Product Change Notice

1.2 ml Dilution Tube Racks with individual and strip tubes⁶ New molded alphanumeric

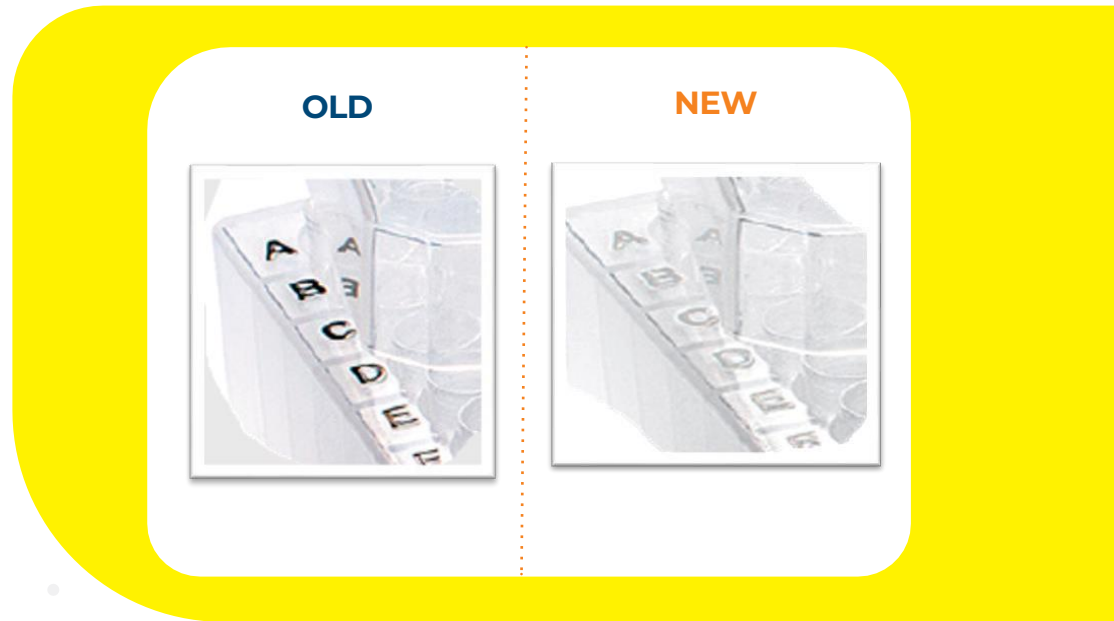
The 1.2 ml Dilution Tube Racks have been modified to incorporate the alphanumeric indexing directly during the moulding process (previously the indexing was pad printed).

- Indexing is now permanently molded into the rack surface (no printed ink).
- Production is simplified, improving efficiency and lead times.
- Removal of solvent-based inks reduces VOC emissions and improves the environmental profile.
- These changes are limited to the indexing and have no effect on FIT, FORM or FUNCTION of the racks or tubes.

Effective from lot: 2209X (and all subsequent lots)
